HEARING DATE: March 14, 2023

SUBJECT: Alexanders Landing Subdivision
H-2022-0084

Annexation of 5.23 acres of land from RUT in Ada County to the R-8 zoning district and preliminary plat consisting of 24 building lots and 4 common lots for Alexanders Landing Subdivision.

D. Open Space Exhibit (dated: 11/2/2022)

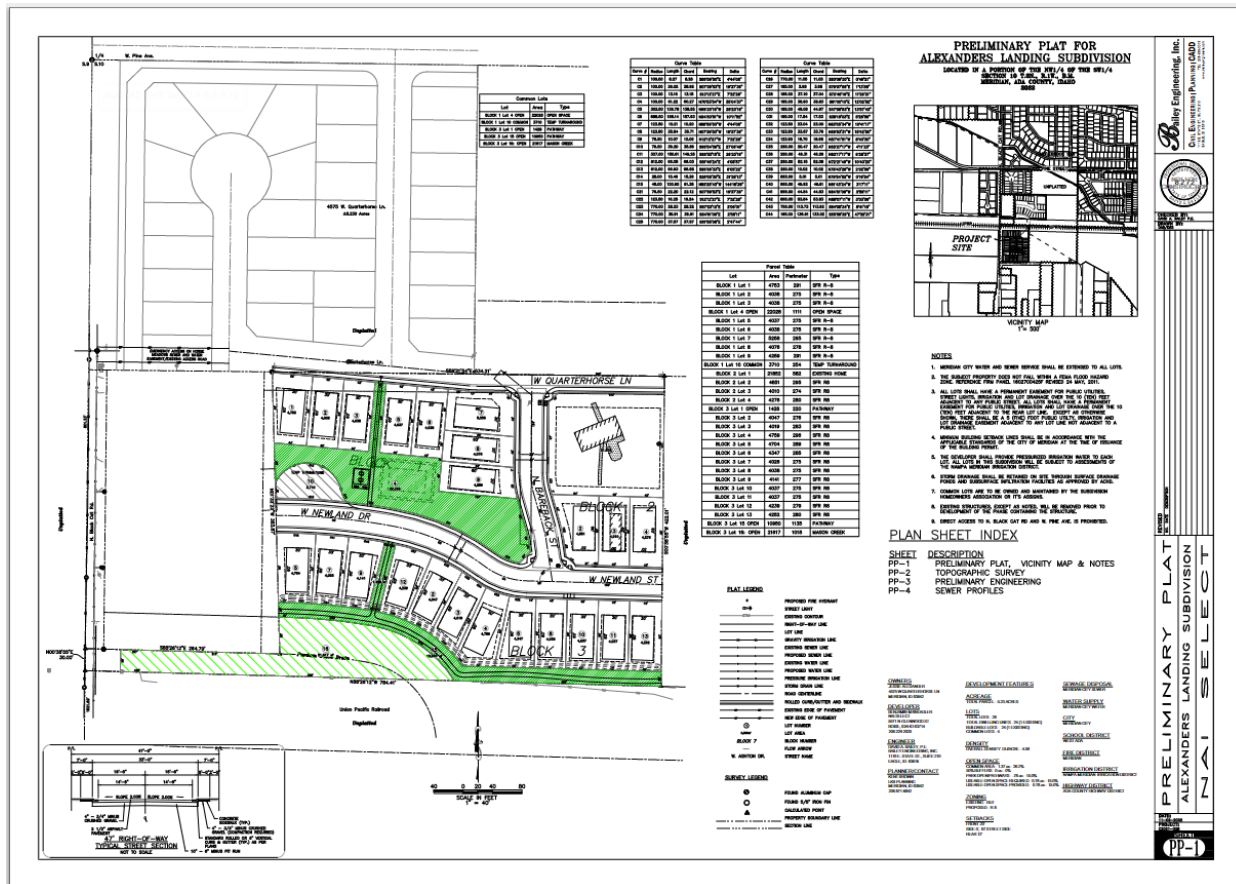
*minimum amount of qualified open space required is 0.78 acres, approximately 34,194 square feet. There are three (3) main open space areas proposed within Alexanders Landing, the centralized common open space, the linear open space along the southern boundary, and the linear open space located on Lot 1, Block 3. The Purdam Gulch Drain does not count as usable open space but is located on Lot 16, Block 3 (21,617 square feet). The Applicant illustrates the drain to remain open in a natural state on the landscape plans submitted as well as stating that all repairs and damage due to construction will be seeded with dryland mix. The large central open space area is approximately 22,028 feet in size and is the largest usable common area within the project. The Applicant has proposed a 5-foot micro-path running north/south within this open space for easy pedestrian access. The linear open space along the southern boundary is approximately 20 feet in width and over 500 feet in length. This linear open space is shown with trees and a 6-foot wide pathway for an added pedestrian element and will also act as a buffer between this project and the railroad to the south. The proposed micro-path on Lot 1, Block 3 connects to the 6-foot wide pathway (a 10-foot wide pathway is recommended below) running along the southern boundary to provide convenient access and pedestrian connectivity. **Because of the pedestrian connectivity and the general locations and uses of open space, Staff supports the proposed qualified open space.***
